**JJDRAFTING AUSTRALIA PTY. LTD**

45a Riviera Ave Avalon (12 Capua Place Avalon)

Please refer to my response to your letter dated 16<sup>th</sup> May 2025

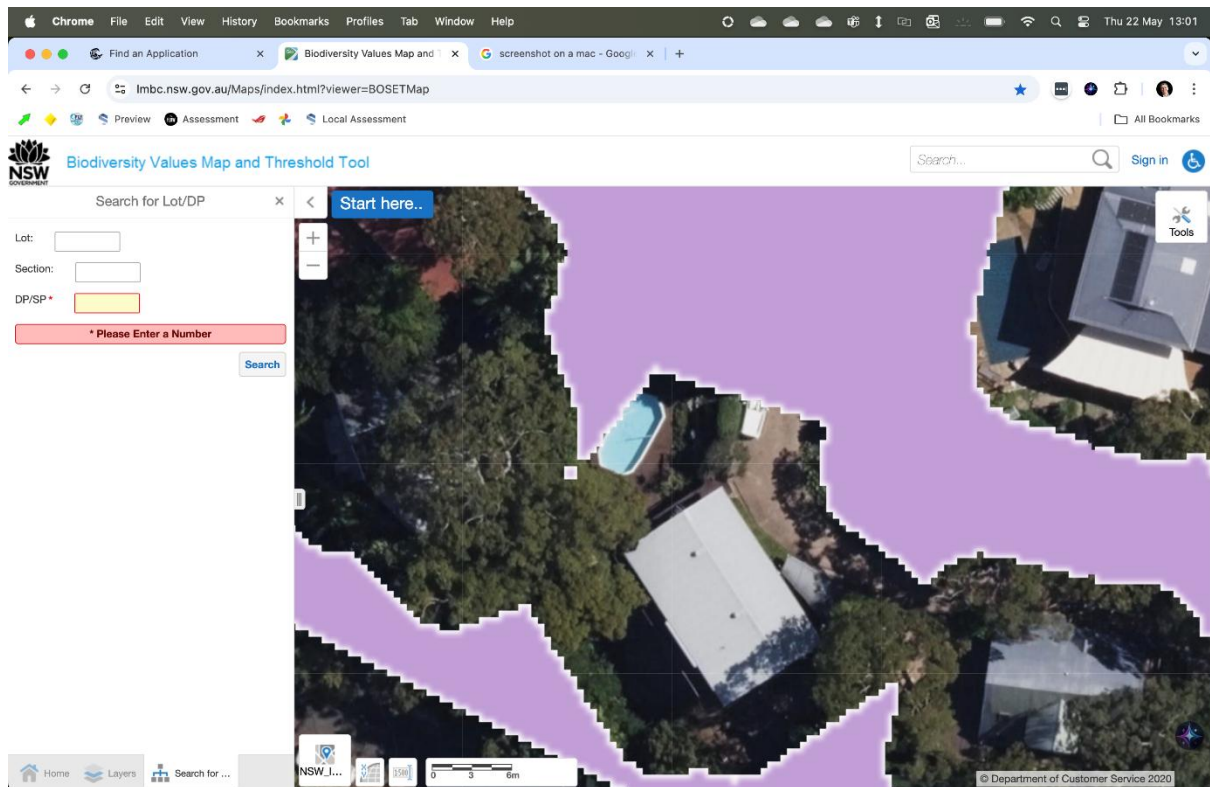
8. **Clause D1.14 Landscaped area – environmentally sensitive land**

This has been covered in the above
